REF: Building Permit No. B18003848, 12541 Westland Court, Fulton, MD 20759
House Type Revision

On November 9, 2018, I applied for this residential building permit for the construction of a "Rutledge" house type, Elevation 5. Since that time, our buyer decided to finish the basement. Attached is the ~~Site Plan~~ and Architecture, as to be built.

Drawing: FINISHED BASEMENT PLAN-1	Project: WILLIAMSBURG GROUP THE RUTLEDGE ESTATE HOME
-----------------------------------	--

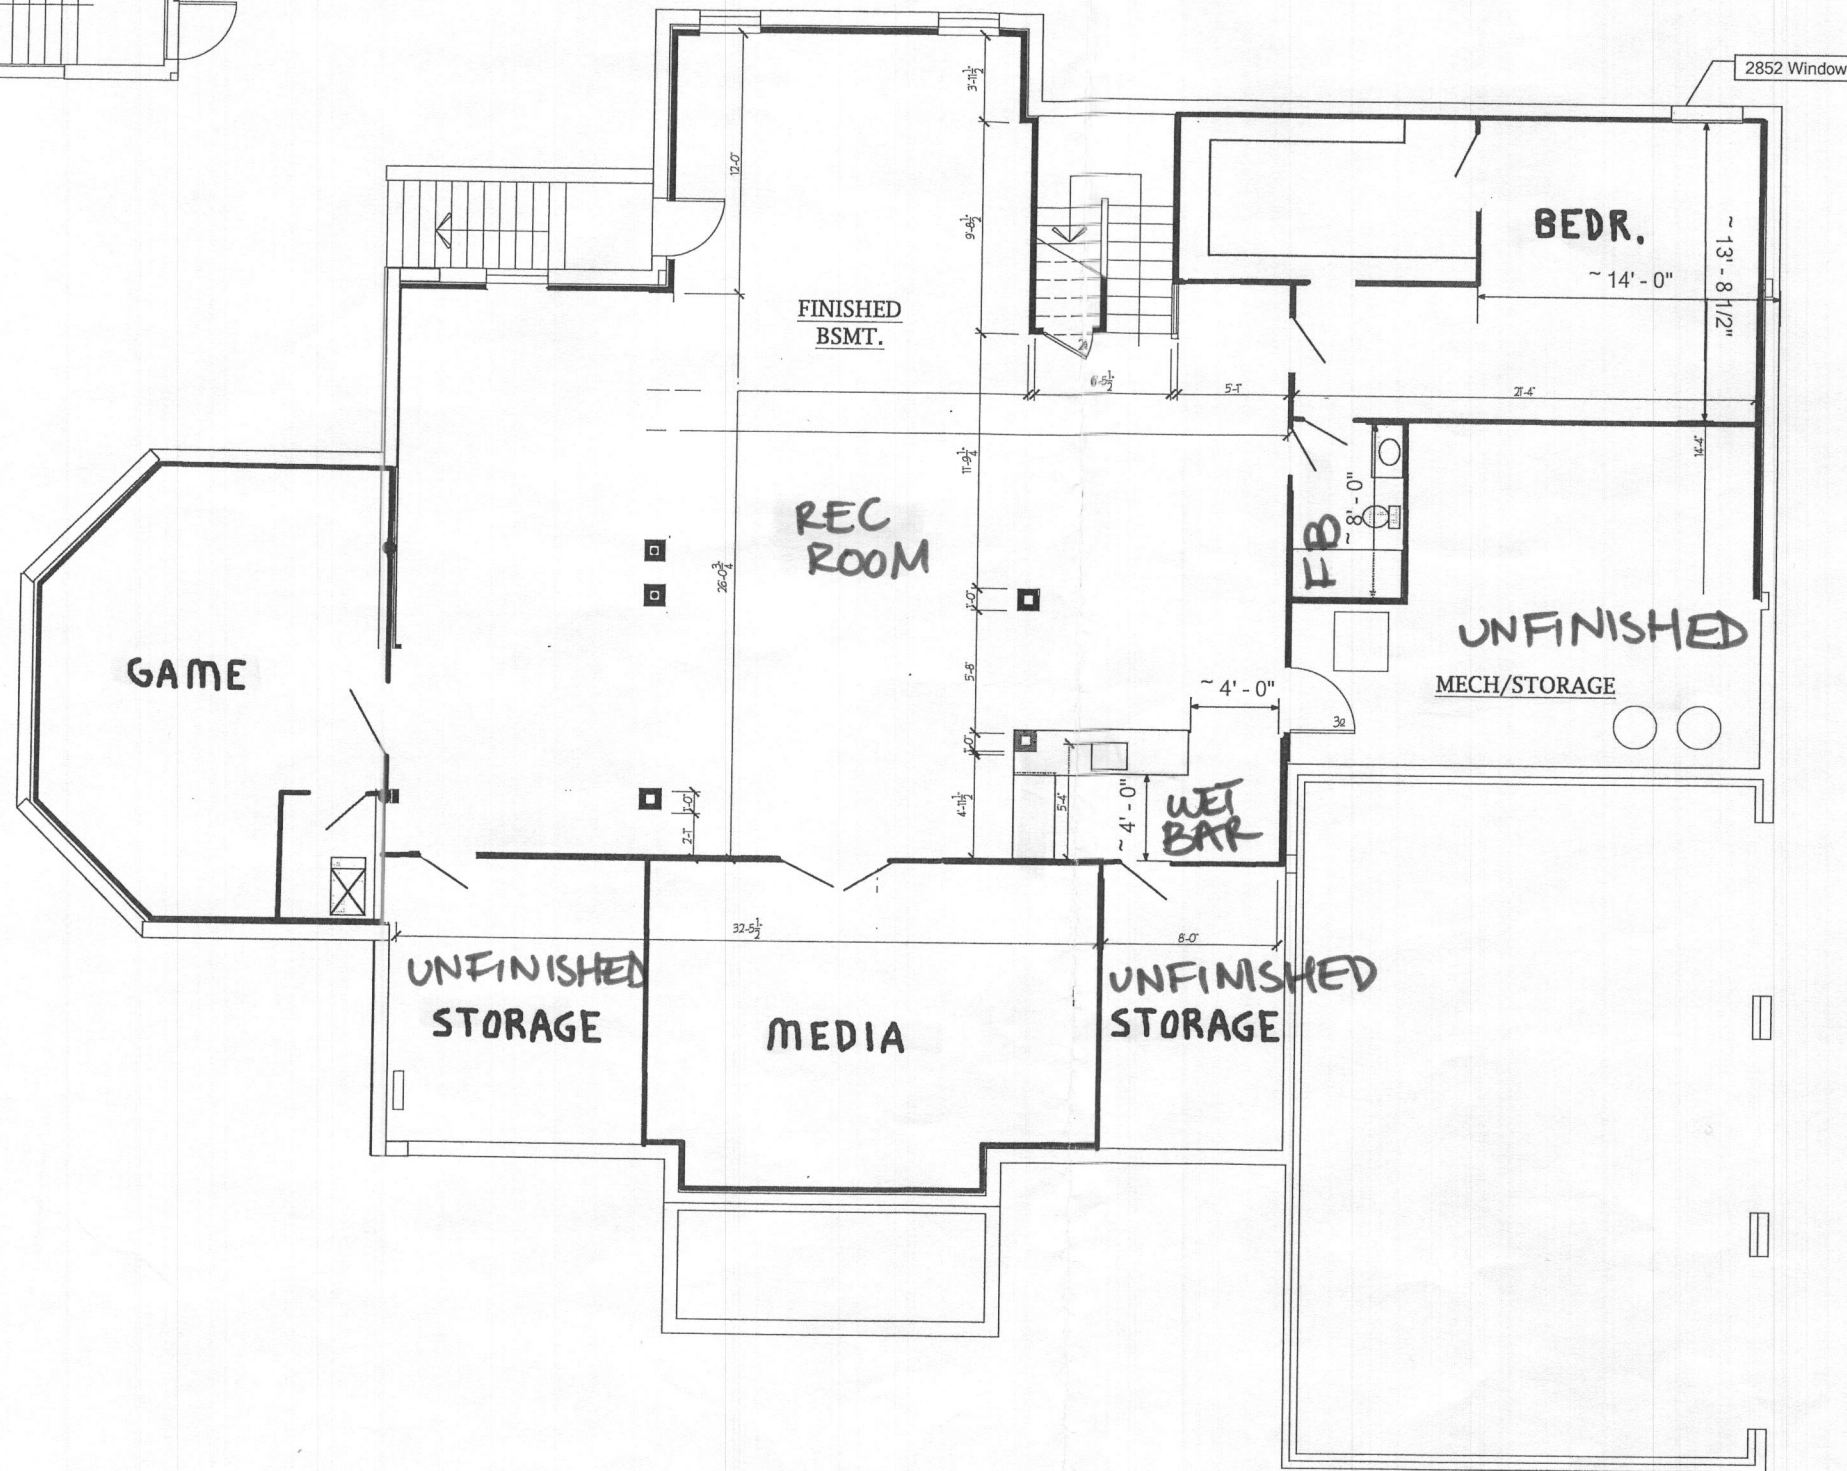
- REC ROOM W/WET BAR
- GAME ROOM
- BEDROOM
- FULL BATH
- MEDIA ROOM
- 2 UNFINISHED STORAGE RM
- UNFIN. MECH/STORAGE RM
- (SEE EMAIL)

REVISED
Date: 4/22/19
Comments: B18003848
FINISH BASEMENT
